**CONTRACT DOCUMENTS & TECHNICAL SPECIFICATIONS
ADDENDUM NO. 1**

**DELAWARE BAYSHORE BYWAY
COOPER-CROSS WILDLIFE VIEWING ENHANCEMENTS
CONTRACT NO. FW-1-15**

Date of Issue: November 6, 2017

SHEET NO.: **S-4**

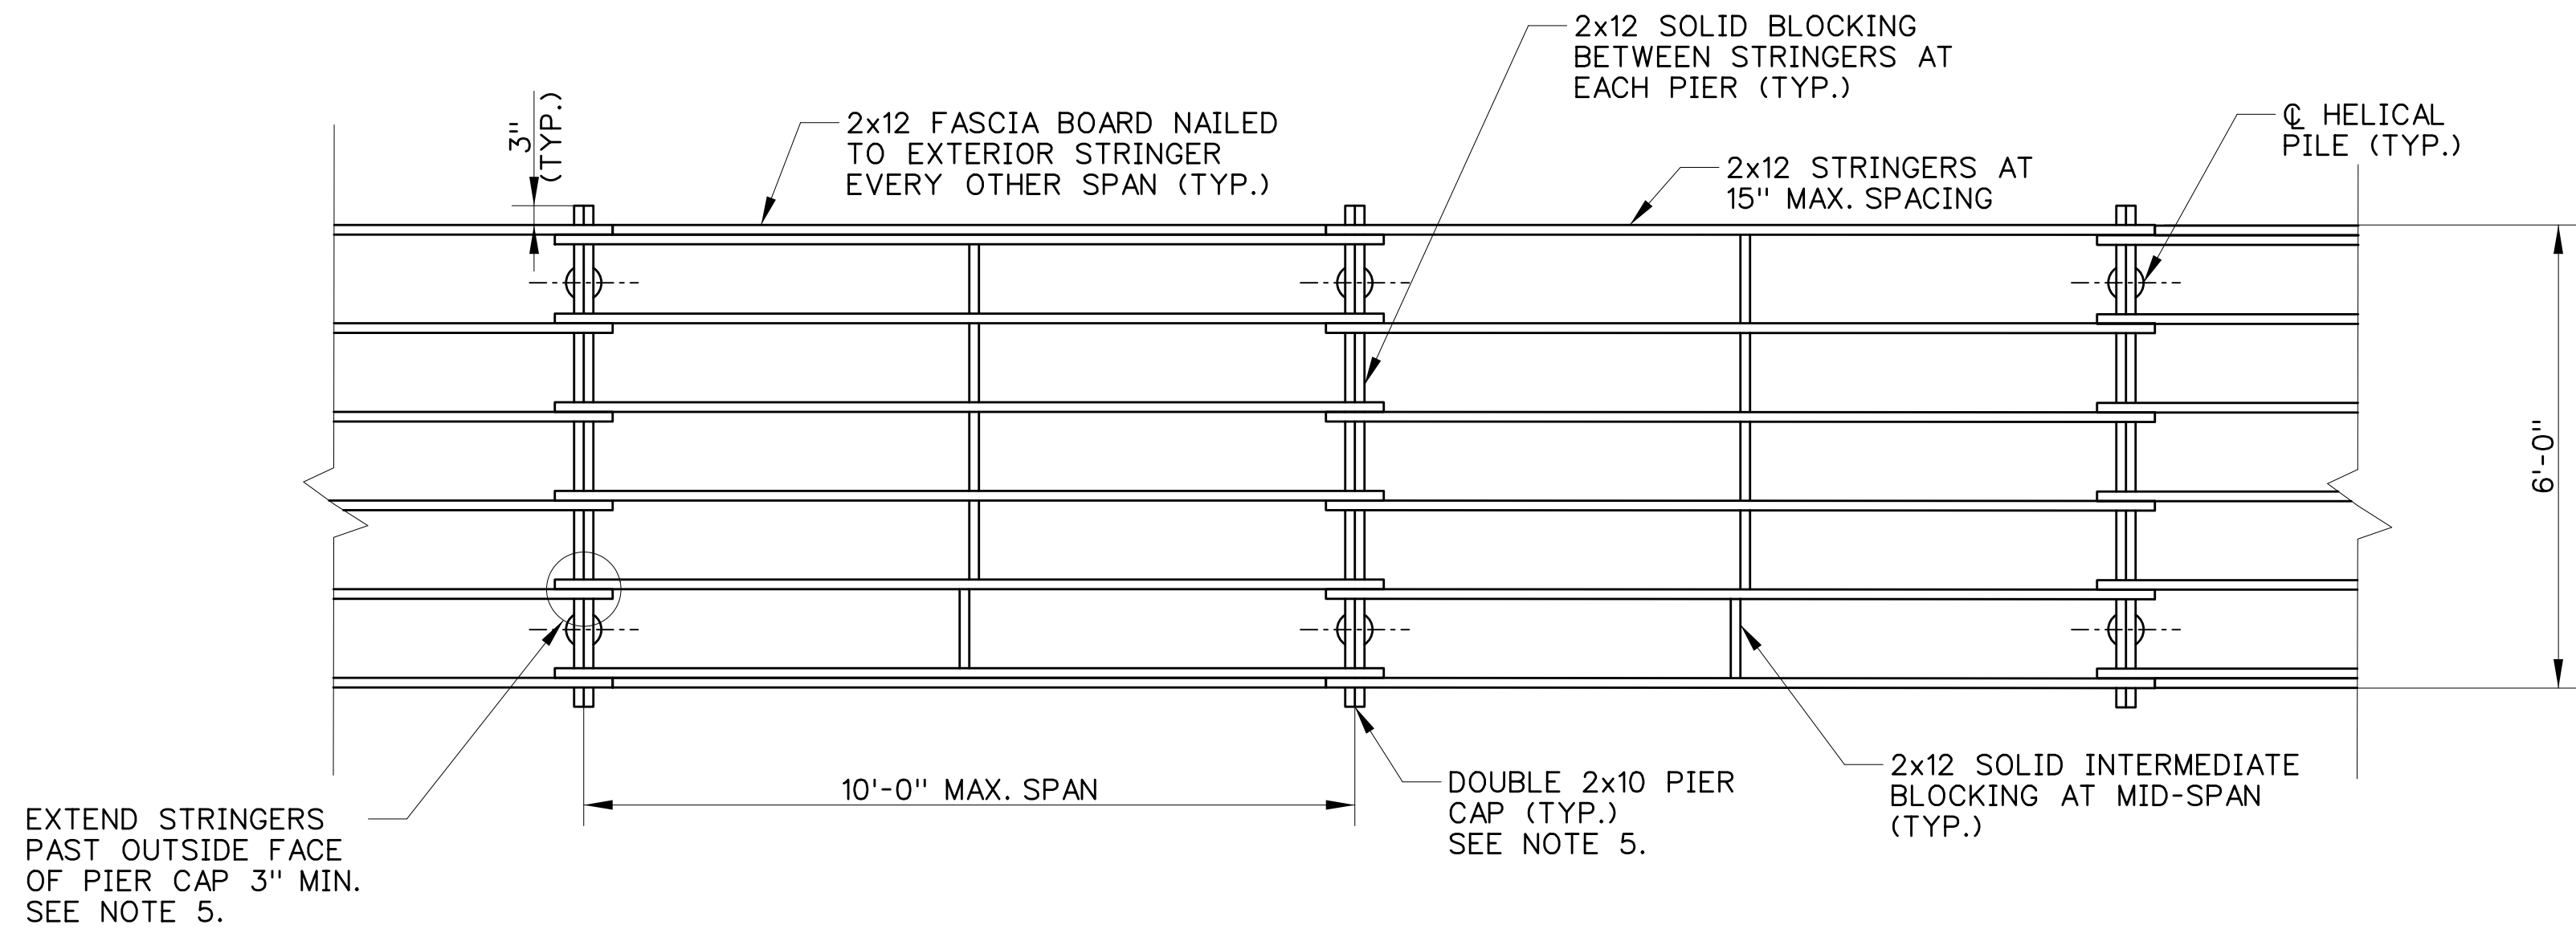
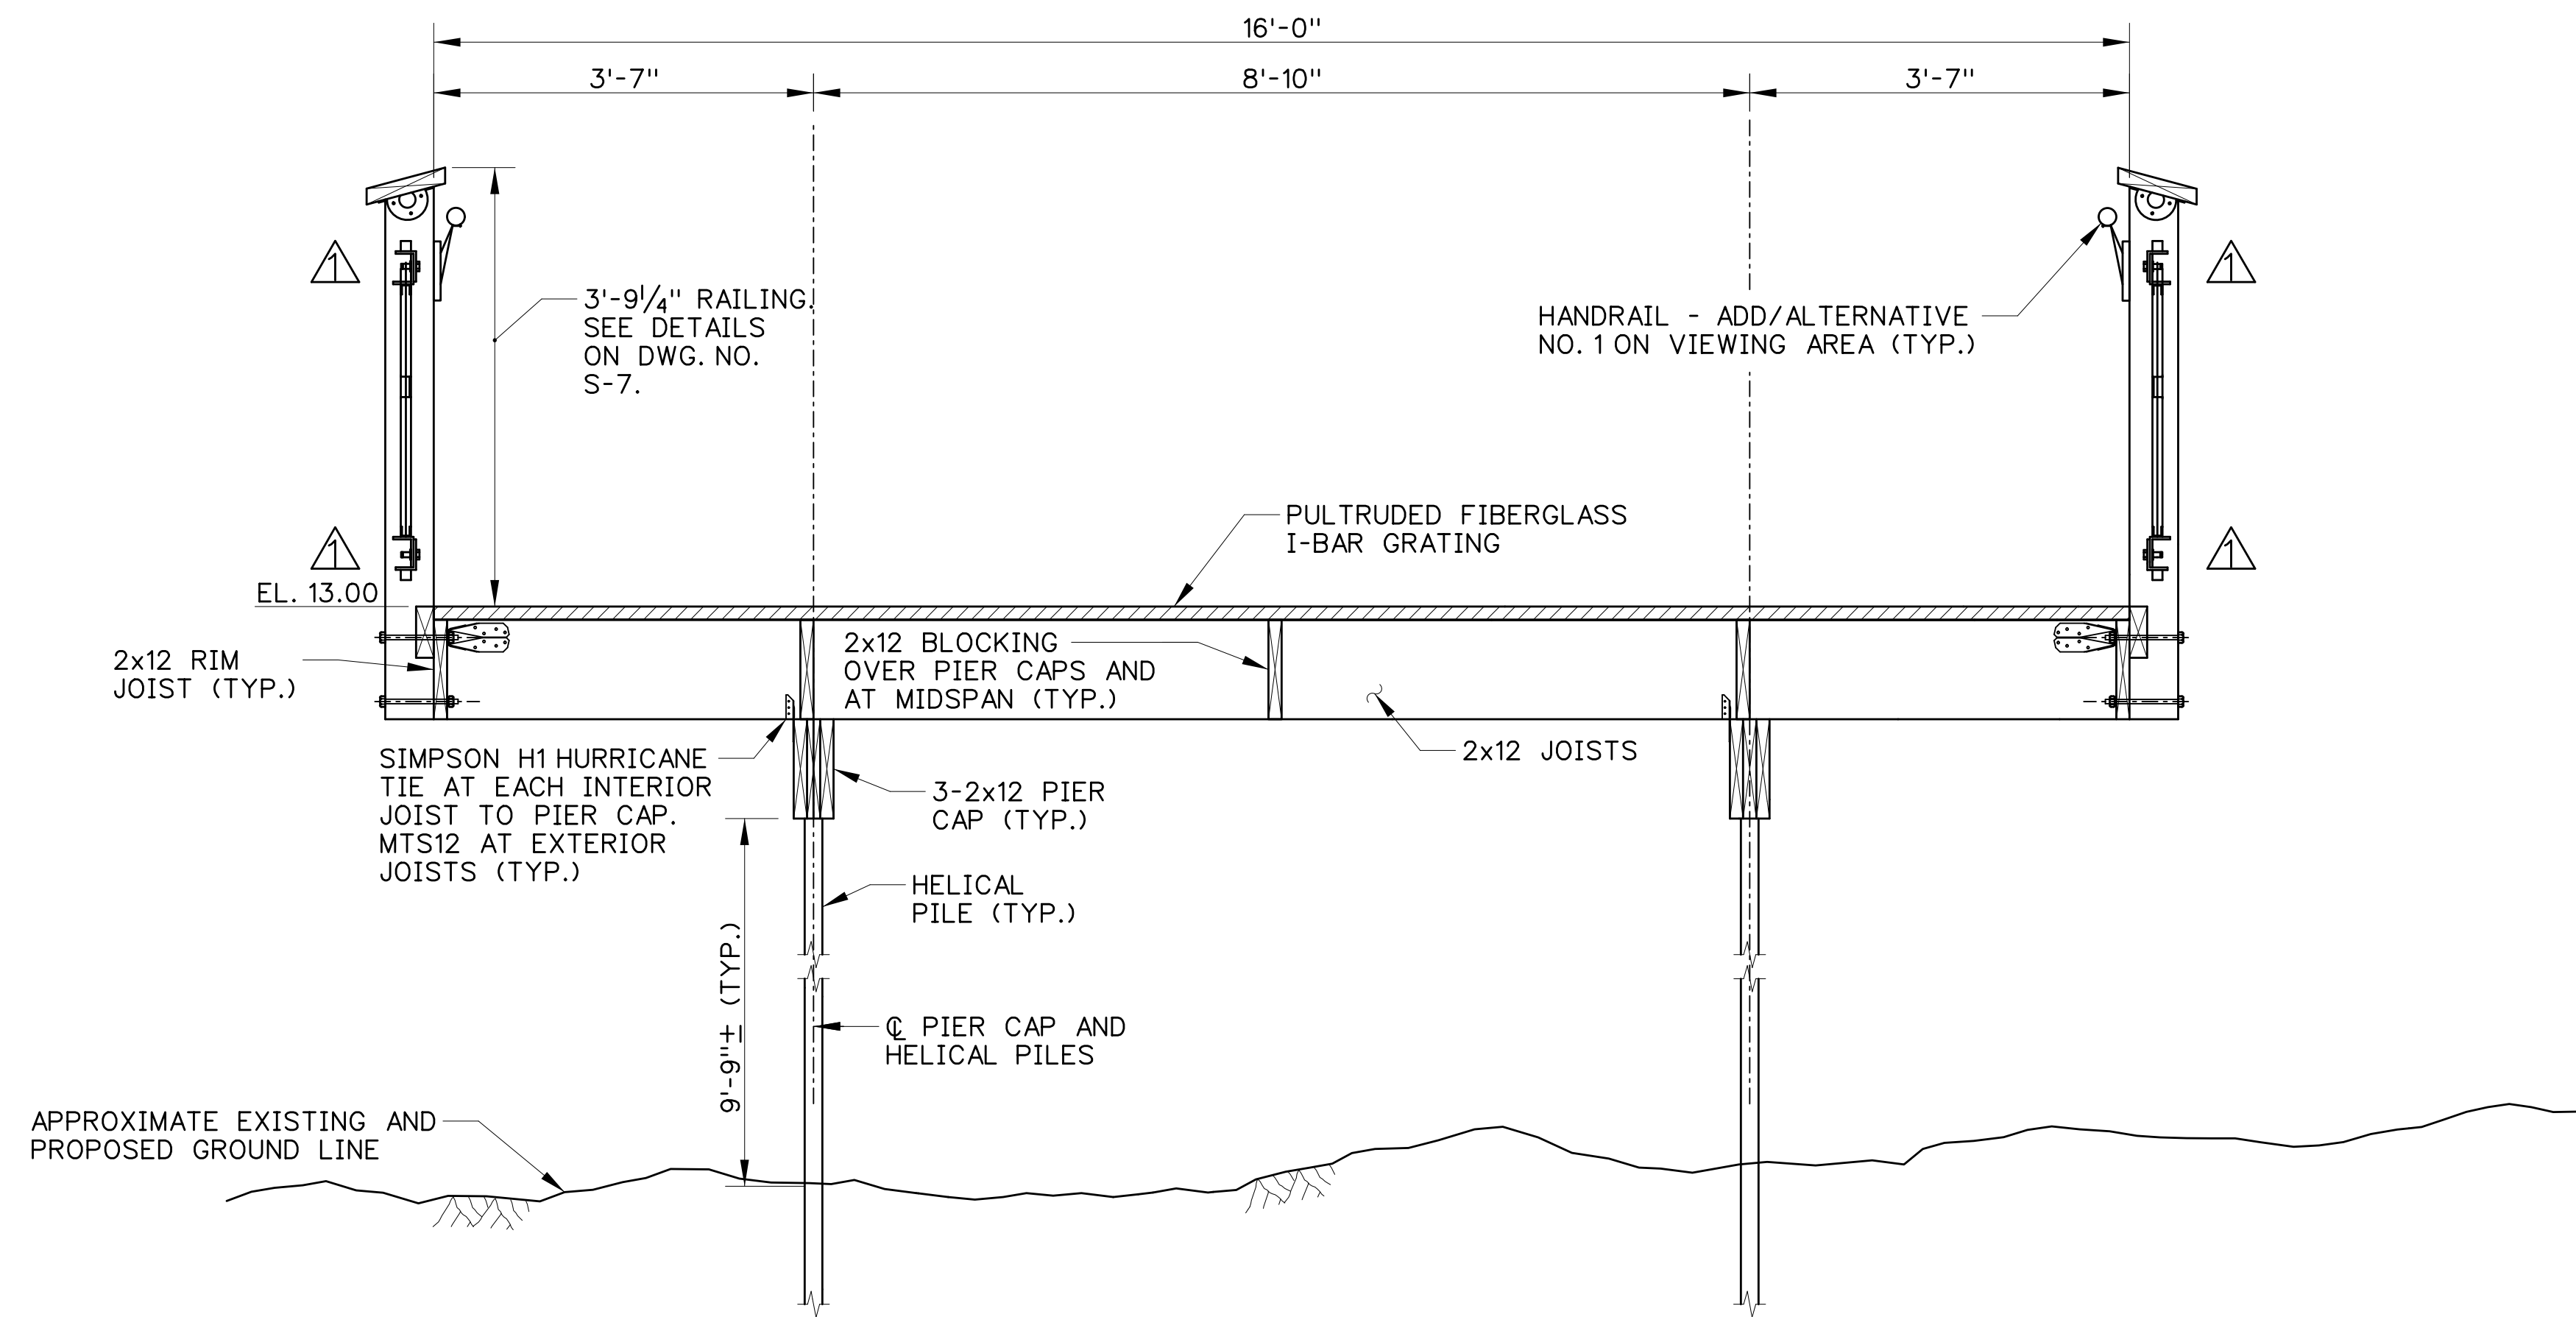
1. **Drawing S-4, S-6, S-7:** Revised direction of angles on the railing.

DELAWARE BAYSHORE BYWAY COOPER-CROSS WILDLIFE VIEWING ENHANCEMENTS	DATE:	11/3/17	REVISION:	REVISED RAILING	BY:	RKK
BOARDWALK TYPICAL SECTION AND FRAMING
